1 Q. Please explain how the operation of the Labrador Island Link would be affected by a
2 3 phase fault at the Holyrood Plant, which is understood could result in prolonged
3 ac voltage oscillation including voltage below 0.8pu.

Figure 1 - 1011NLONLY - HRD TL268 Fault - Relative Rotor Angle (Degrees)

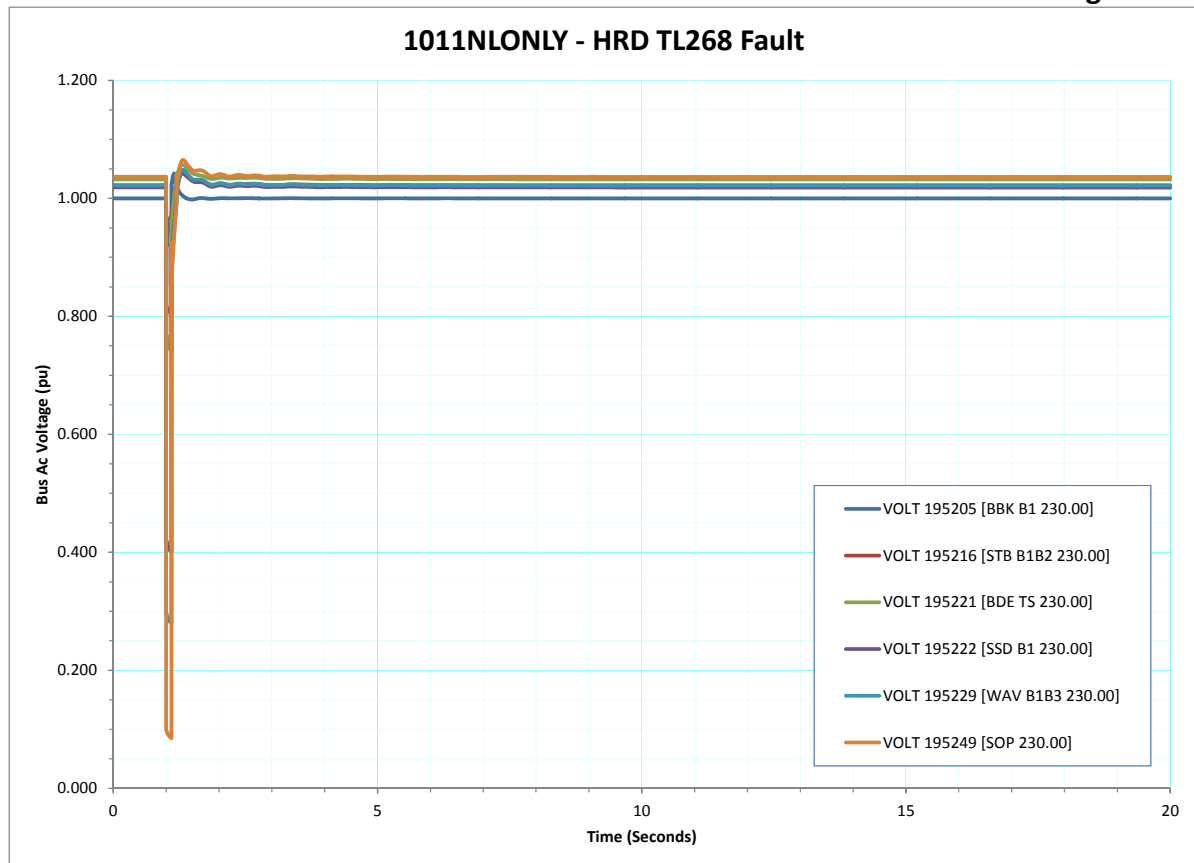
14 Simulations were performed using the peak load case with the LIL loaded to 900
15 MW to demonstrate the system response to three-phase faults at Holyrood
16 followed by:

- 17 • The tripping of a transmission line to Soldiers Pond Terminal Station
18 (TL268);
- 19 • The tripping of a transmission line to Oxen Pond Terminal Station
20 (TL218); and
- 21 • The tripping of a synchronous condenser.

6 A. A three-phase fault at Holyrood could result in prolonged ac voltage oscillation
7 including voltage below 0.8 pu when the Holyrood Thermal Generating Station is
8 online. Prolonged Holyrood bus voltages below 0.8 pu can be problematic for the
9 thermal plant auxiliaries and result in loss of Holyrood thermal generation. When
10 the Labrador-Island Link (LIL) is commissioned, the Holyrood Thermal Generating
11 Station will not be in operational service (during times when the LIL is operational)
12 and a three-phase fault at Holyrood does not result in system instability.

23 As demonstrated in the figures below, ac stability is maintained and system
24 voltages are held within acceptable limits for these cases.
